WALNUT GROVE VILLAGE TWIN CHIMNEYS

VILLAGE G

STORM & SANITARY SEWER MEASUREMENTS

VOLZ 88-2860

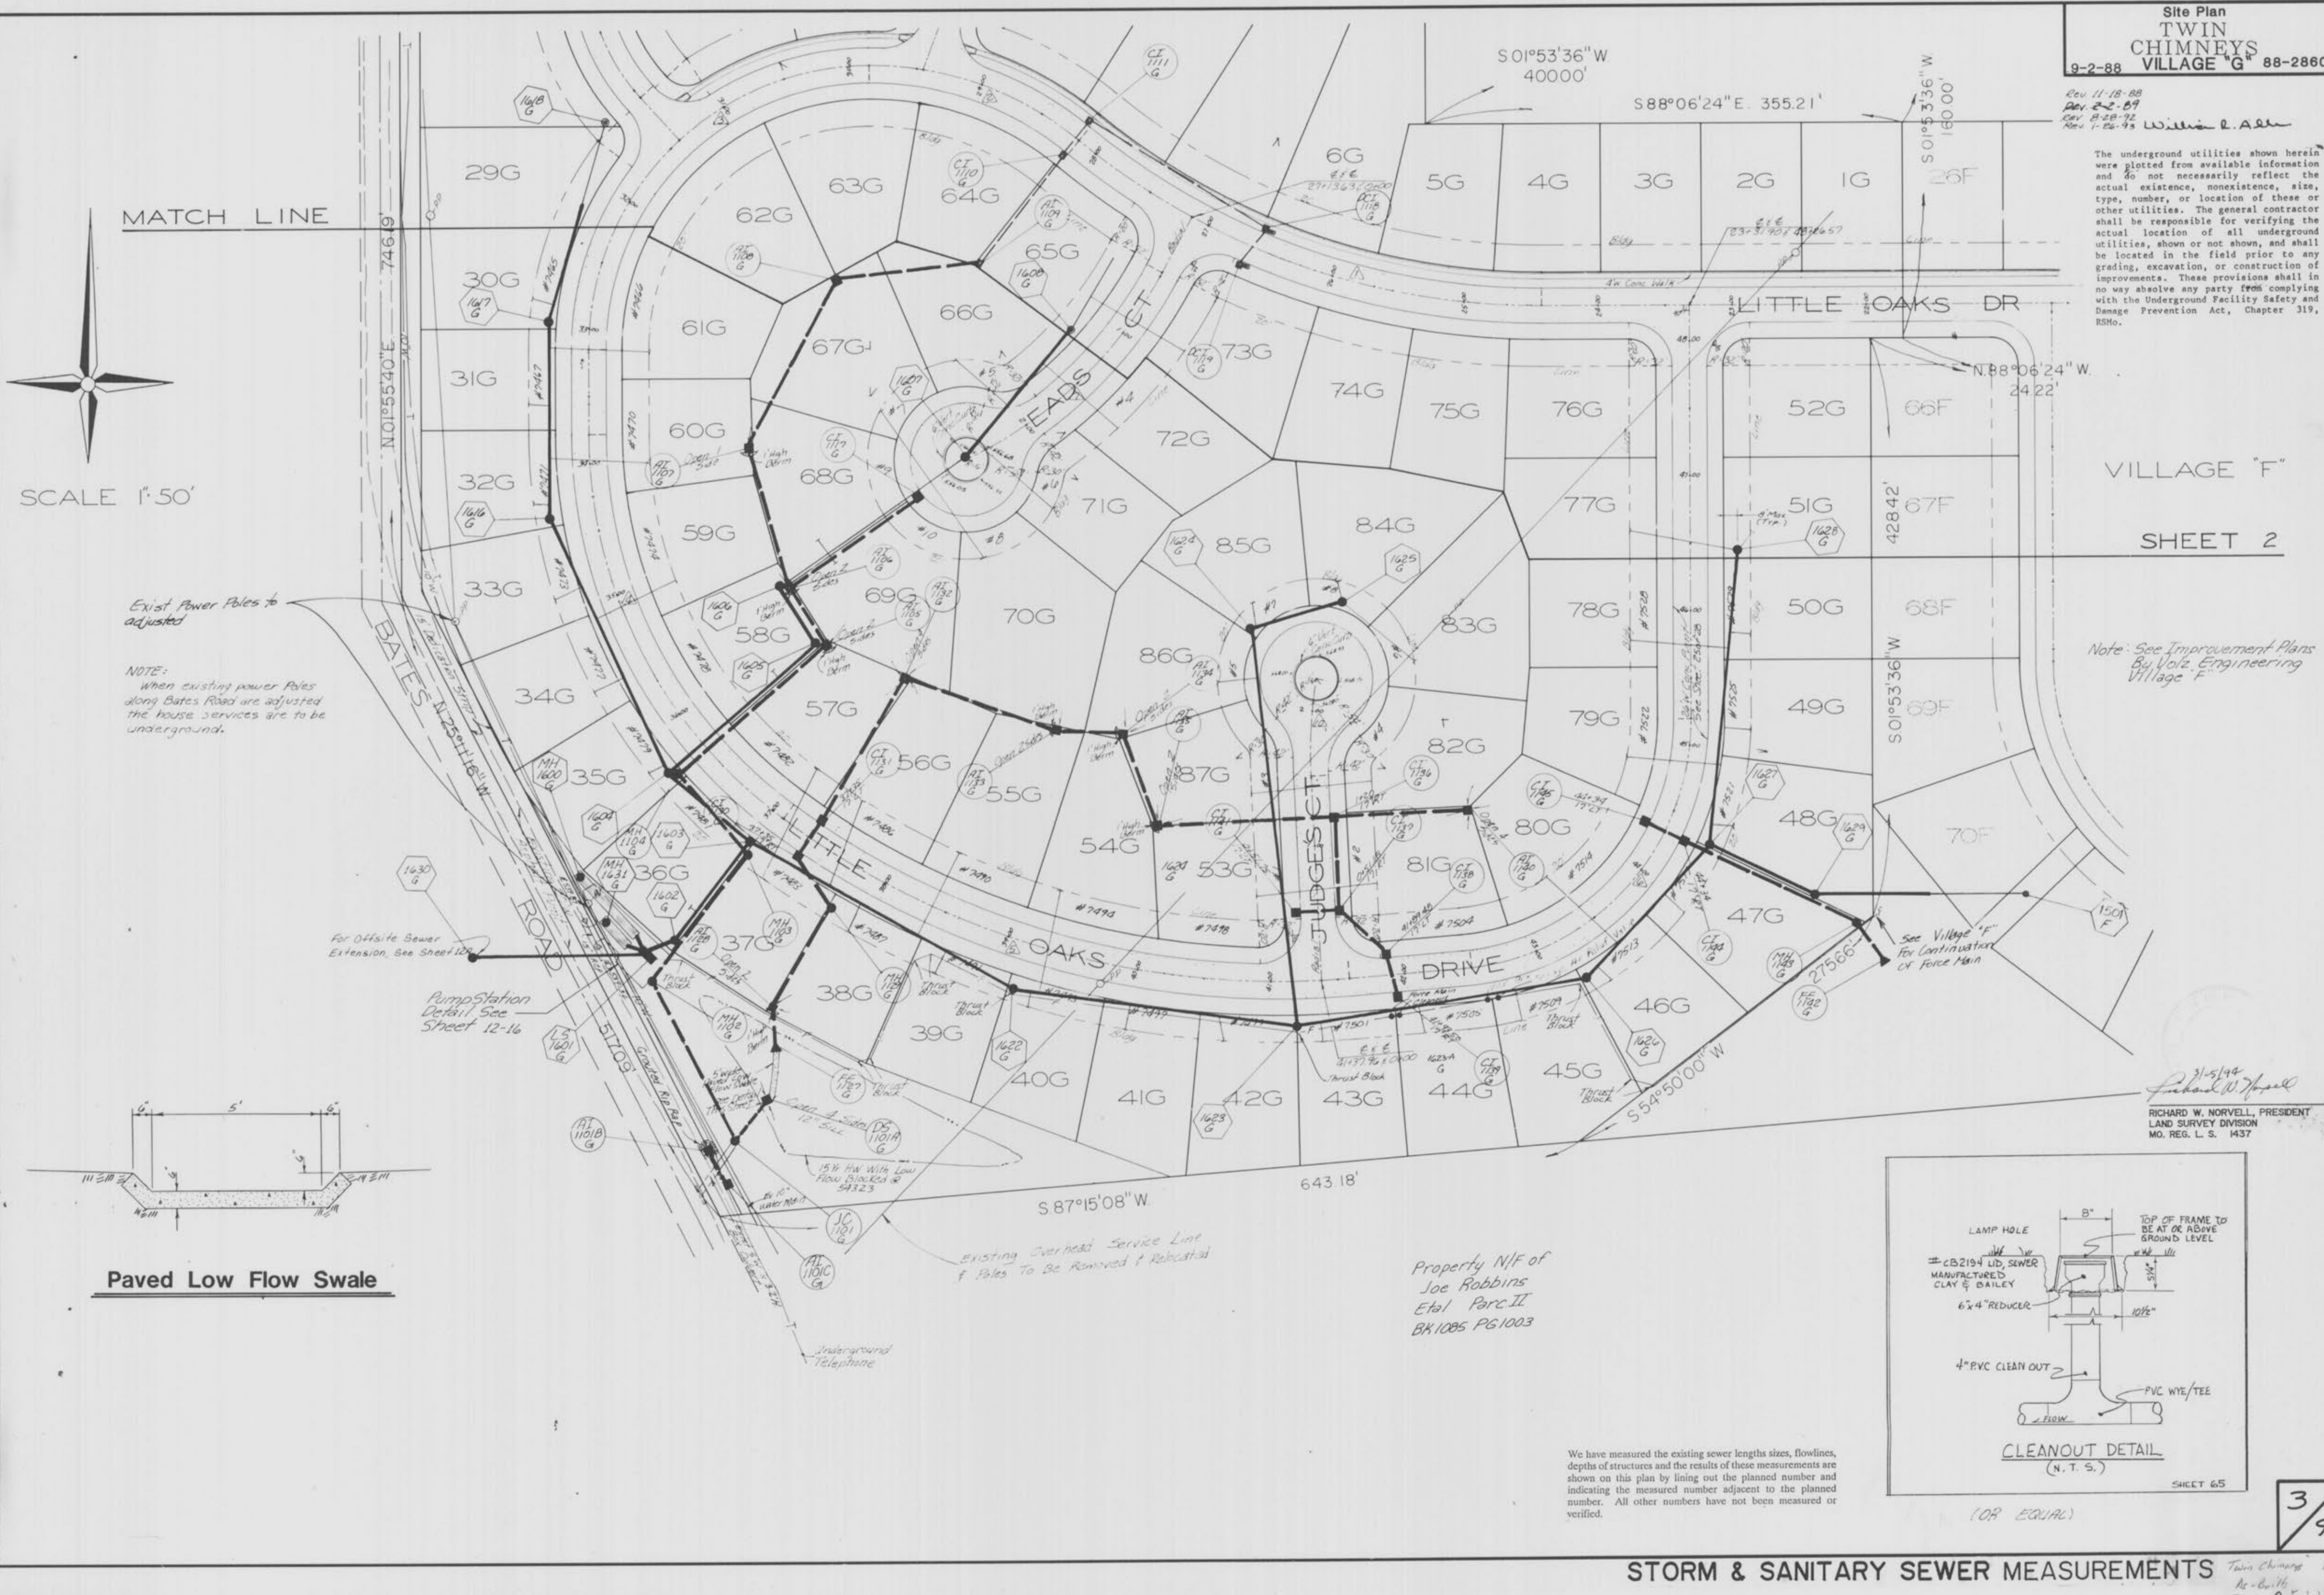
We have measured the existing sewer lengths, sizes, flowlines, depths of structures and the results of these measurements are shown on this plan by lining out the planned number and indicating the measured number adjacent to the planned number. All other numbers have not been measured or verified.

Sanitary Sewer Profiles
TWIN CHIMNEYS VILLAGE "G" 88-2860

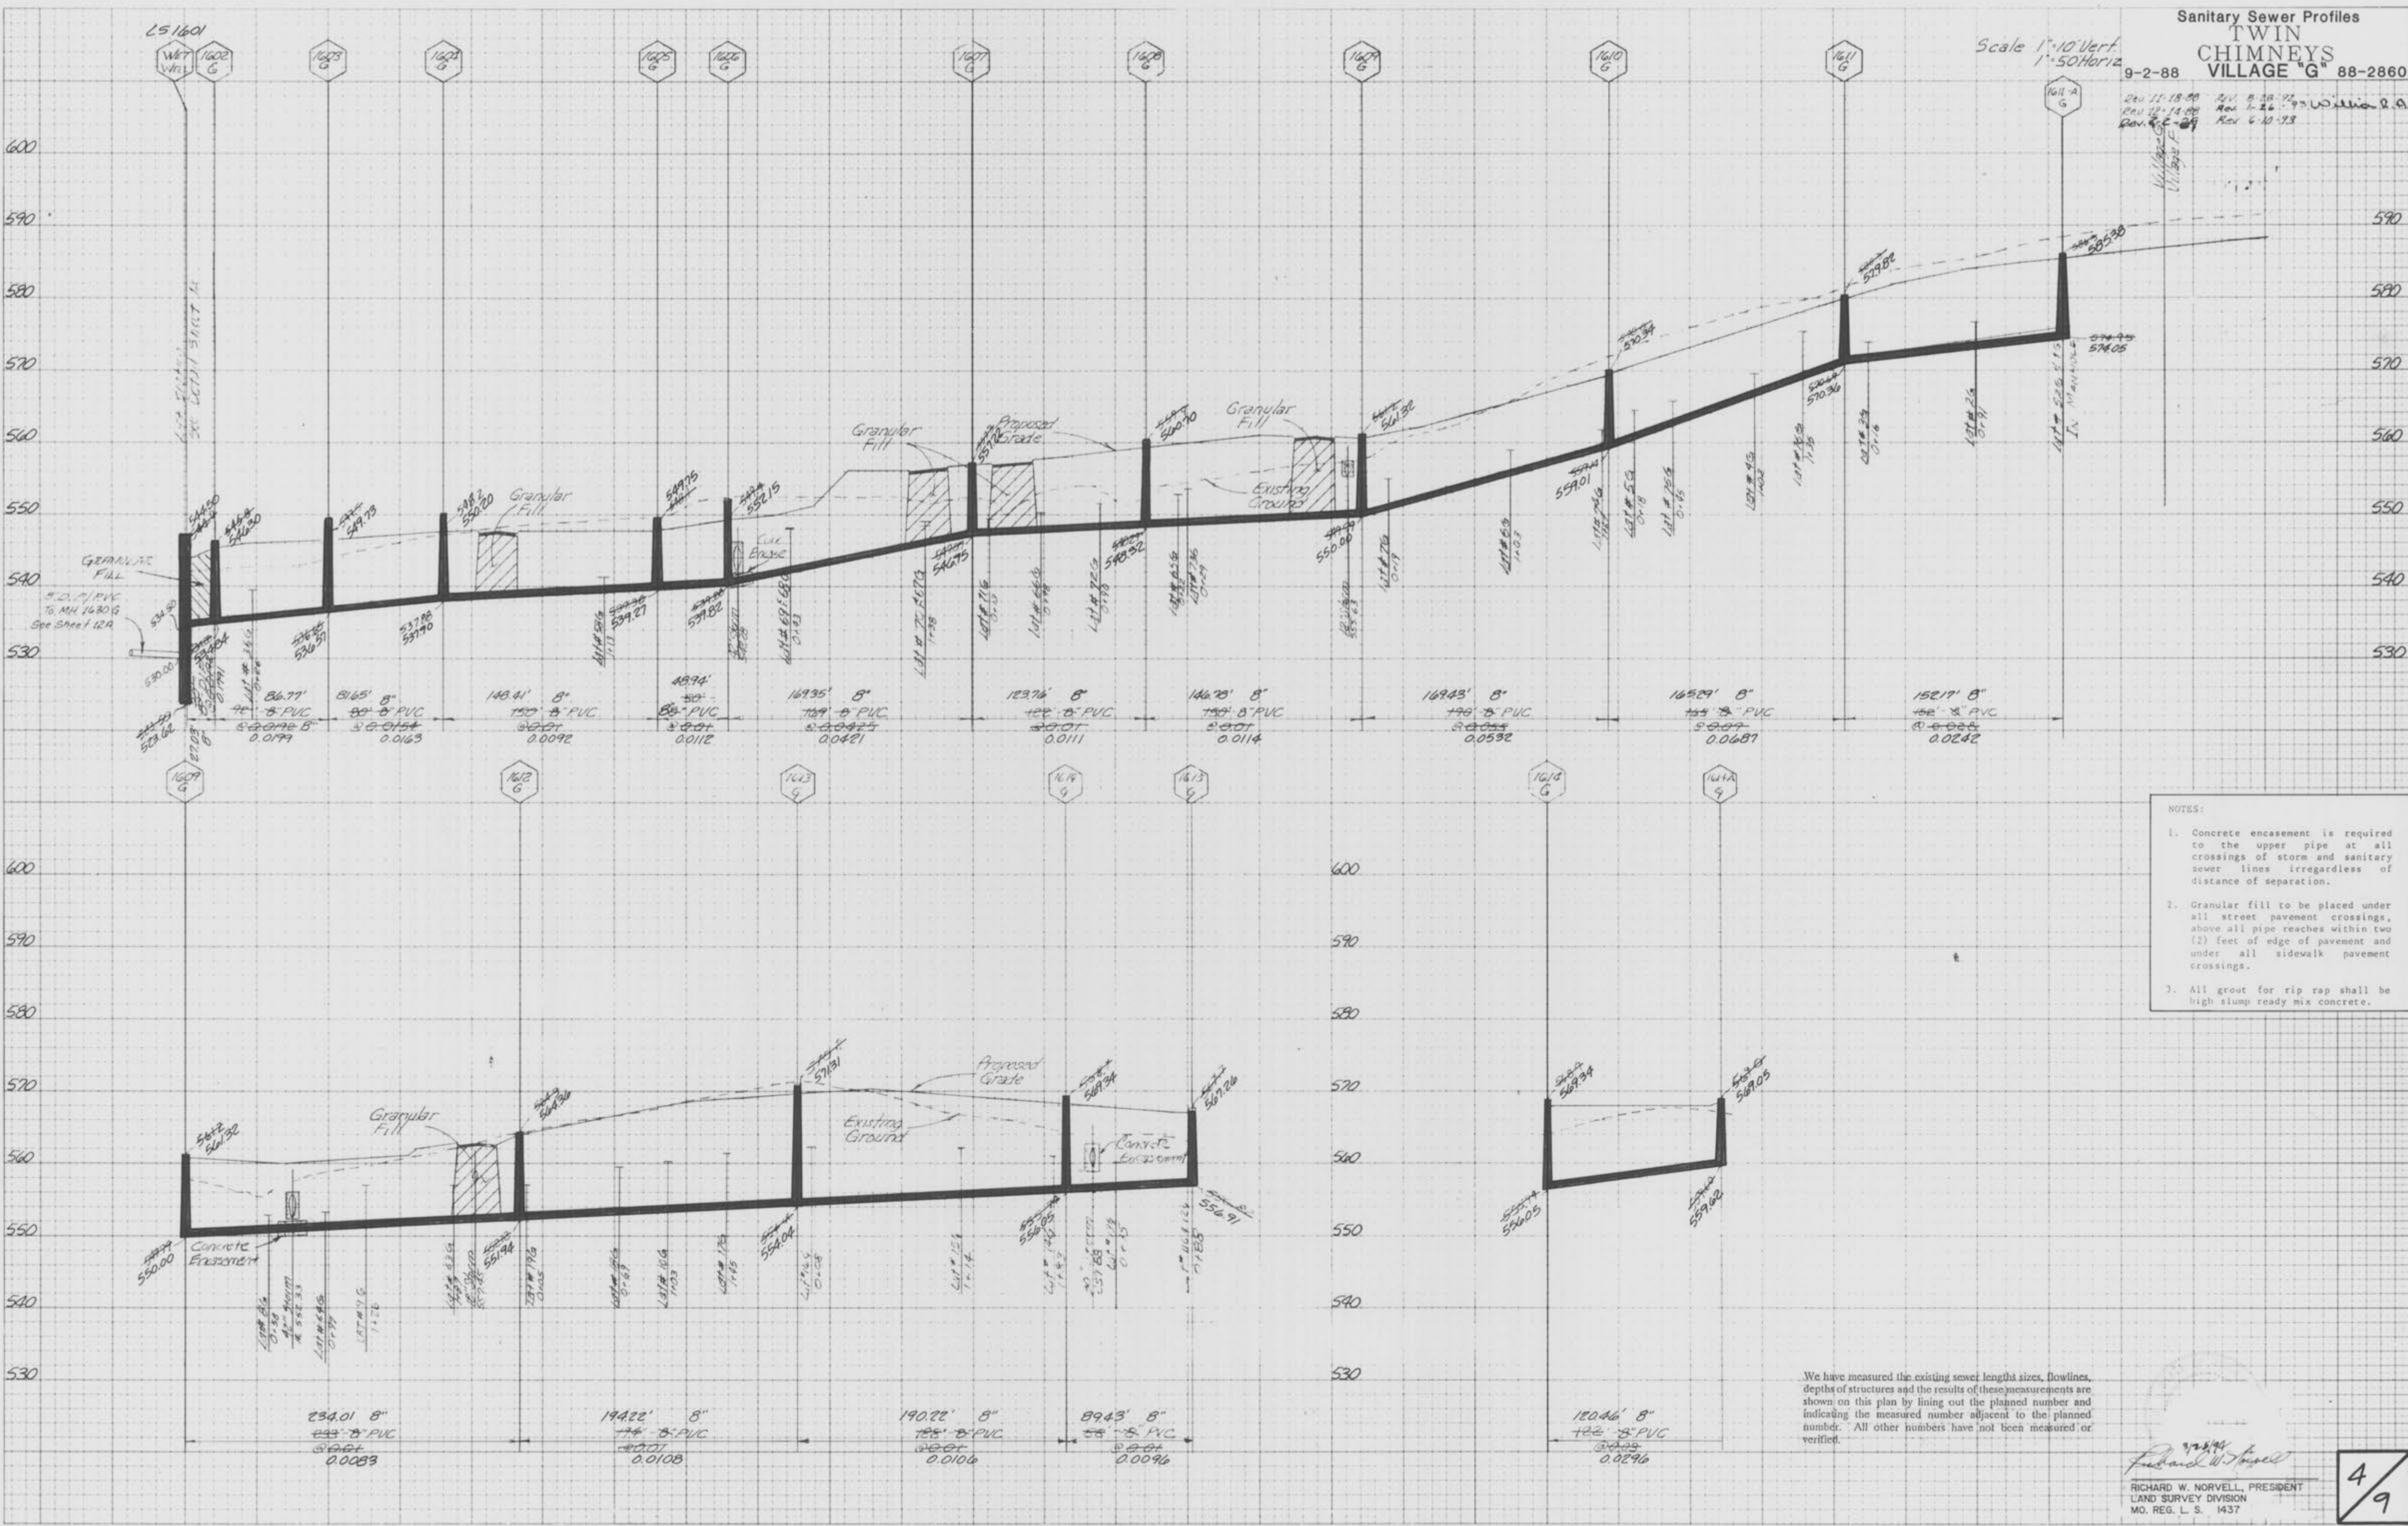
We have measured the existing sewer length sizes, flowlines, depths of structures and the results of these measurements are shown on this plan by lining out the planned number and indicating the measured number adjacent to the planned number. All other numbers have not been measured or verified.

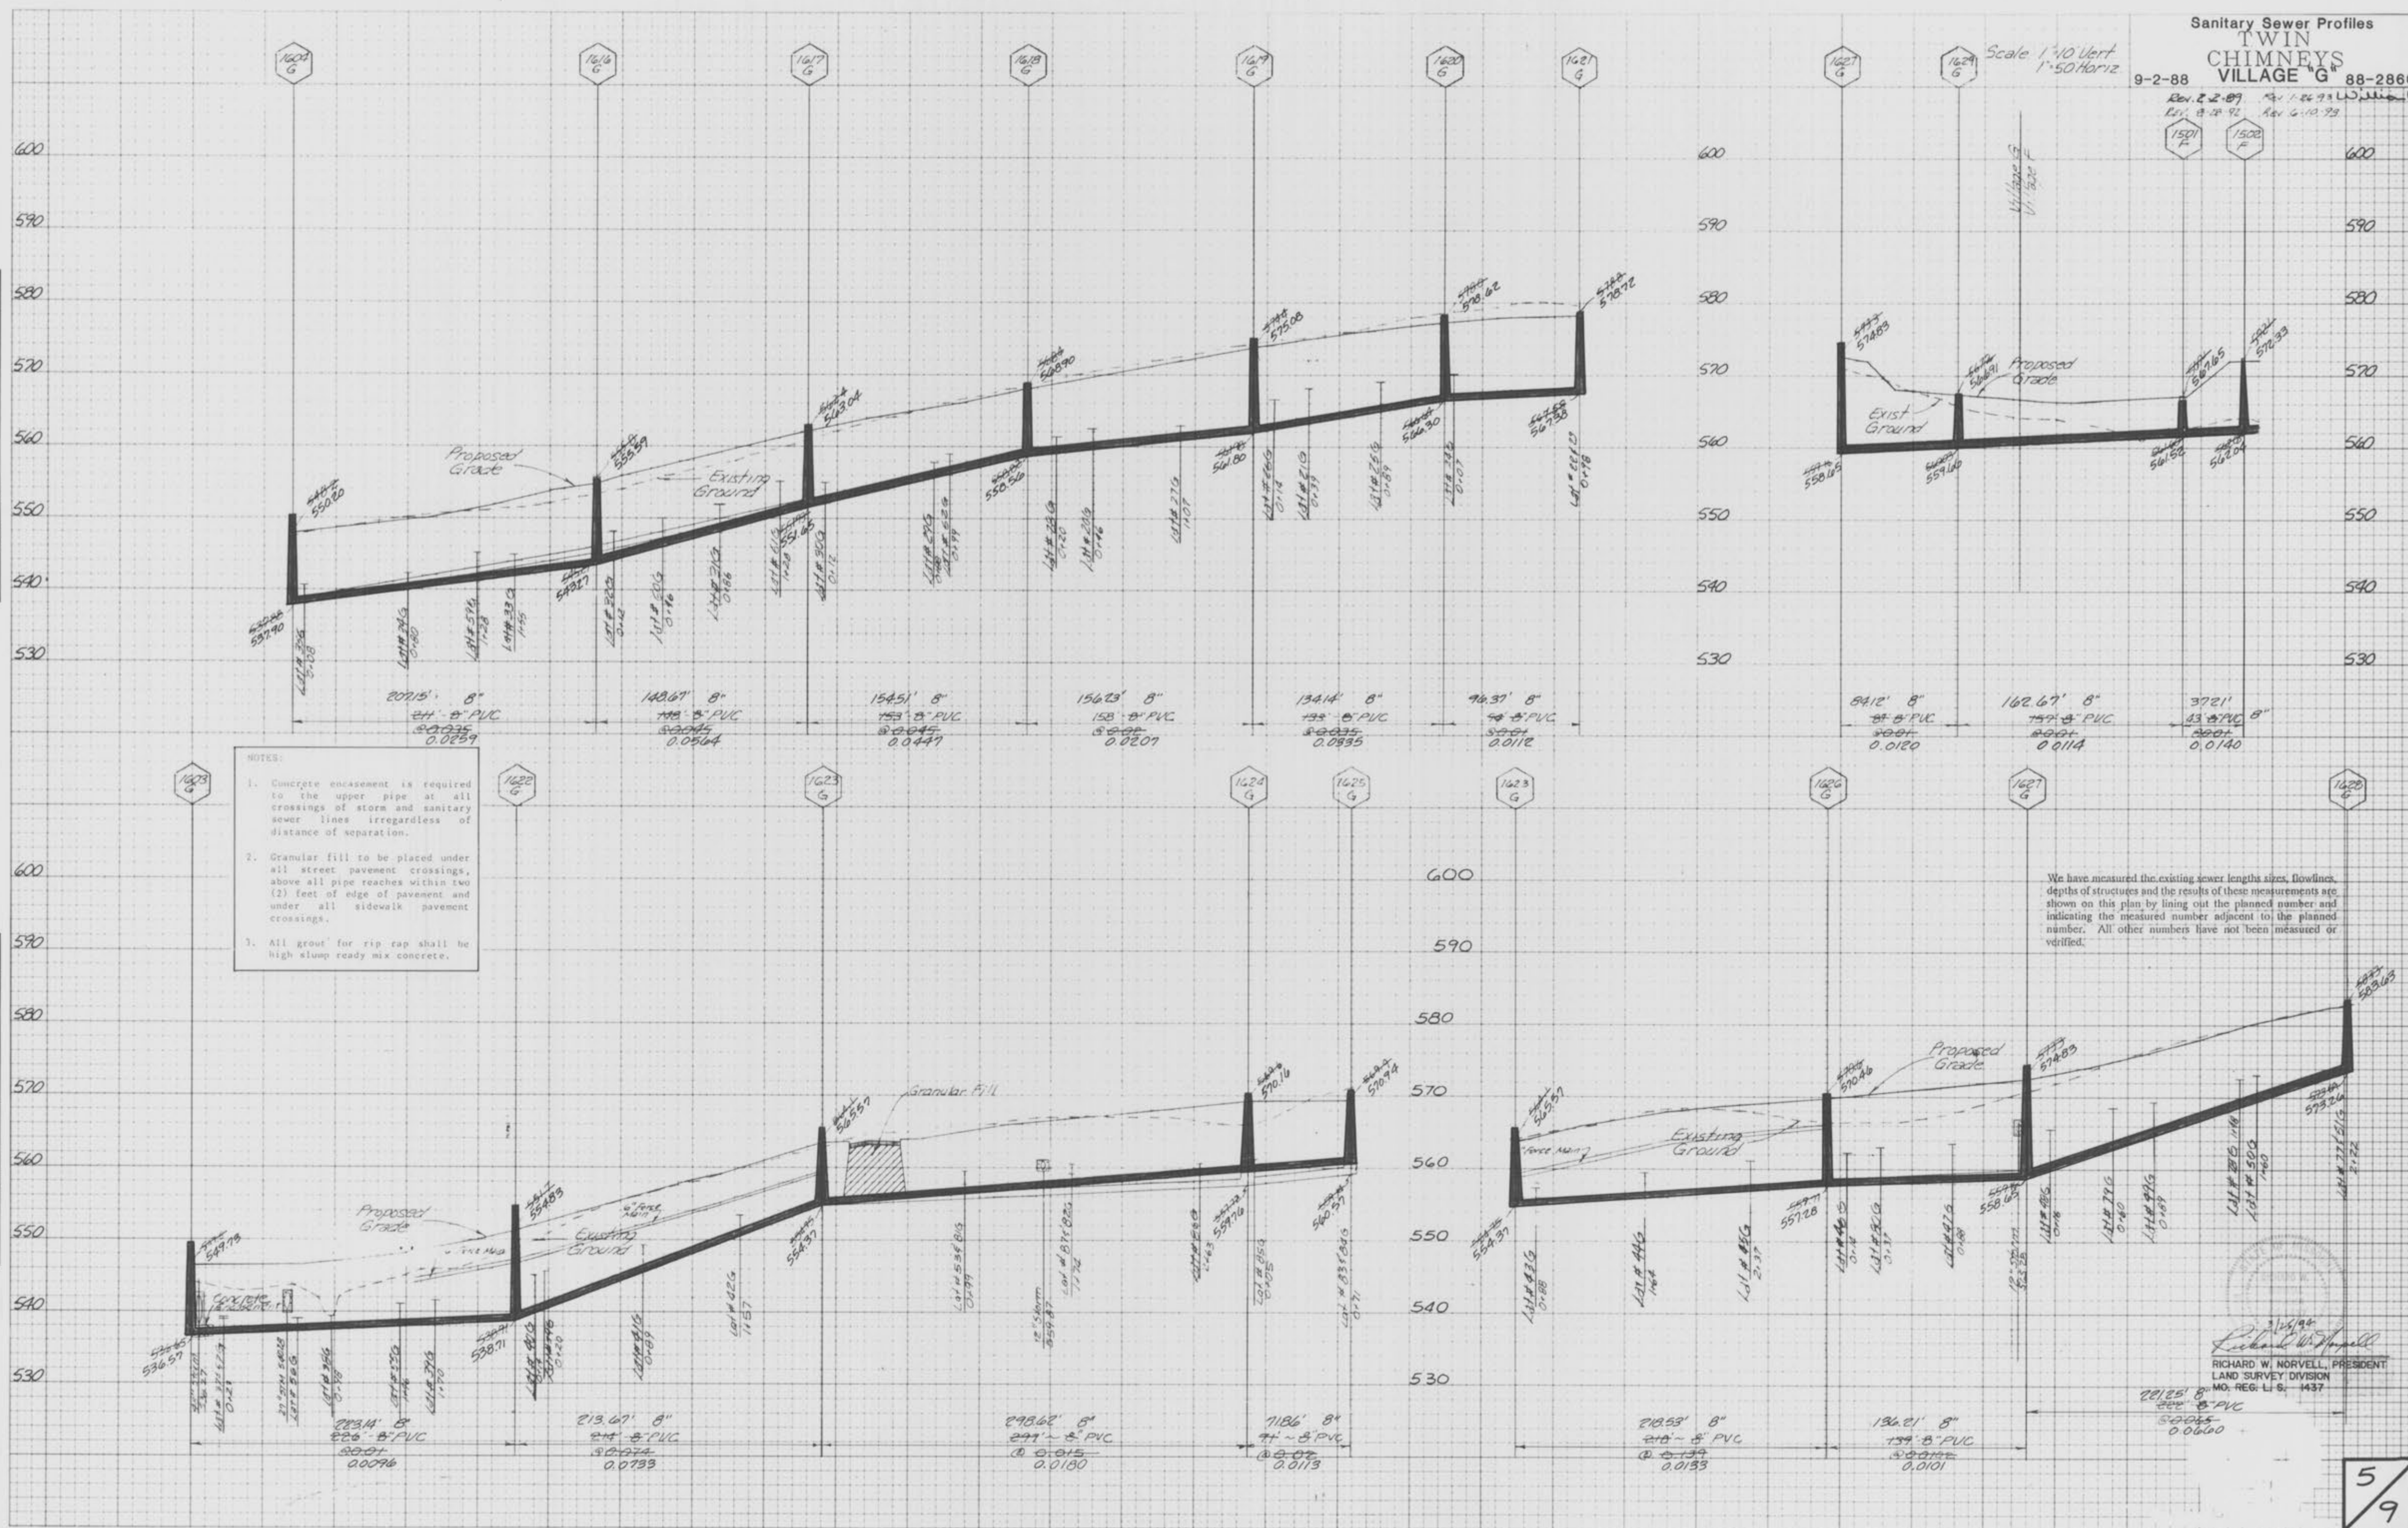
We have measured the existing sewer lengths, sizes, flowlines, depths of structures and the results of these measurements are shown on this plan by lining out the planned number and indicating the measured number adjacent to the planned number. All other numbers have not been measured or verified.
